SEEGER-INGLE SUBDIVISION

The plat illustrates the proposed $1.6\pm$ acre, 2-lot subdivision, which is located on the North side of Overlook Road, $200'\pm$ East of the North terminus of Lucerne Drive. The site is served by public water and sanitary sewer.

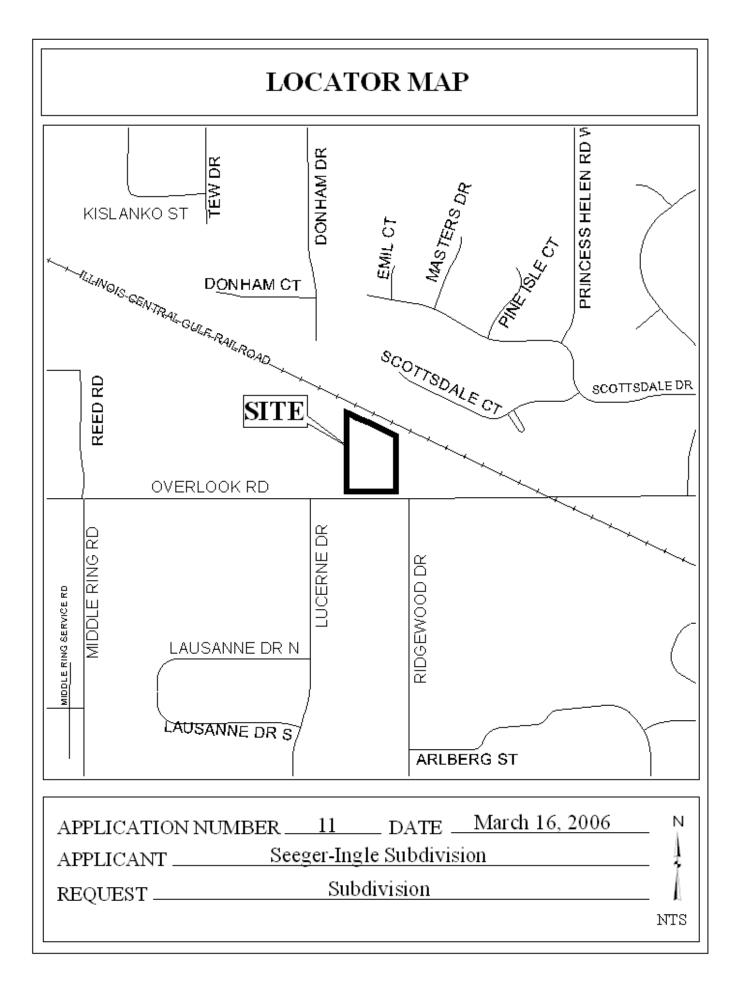
<u>Engineering Comments:</u> Must comply with the Mobile County Flood Damage Prevention Ordinance.

The purpose of the application is to create two lots from a metes and bounds parcel. The required 25-foot setback lines are not shown and would be required on the final plat.

Proposed Lot 1 would exceed the maximum depth-to-width ratio. However, existing development on proposed Lot 2, together with the proximity and angle of the railroad contribute to that situation, which is not uncommon on nearby lots south of the railroad. Therefore a waiver of the relevant Subdivision Regulation (V.D.3, maximum depth) would be recommended.

The site is located in the County; thus any lots that are developed commercially and adjoin residentially developed property must provide a buffer, in compliance with Section V.A.7 of the Subdivision Regulations.

With a waiver of Section V.D.3, the plat would meet the minimum requirements of the Subdivision Regulations and is recommended for Tentative Approval, subject to the following conditions: 1) the depiction of the 25-foot setback lines on the final plat; and 2) the placement of a note on the final plat stating that any lots that are developed commercially and adjoin residentially developed property must provide a buffer, in compliance with Section V.A.7 of the Subdivision Regulations.
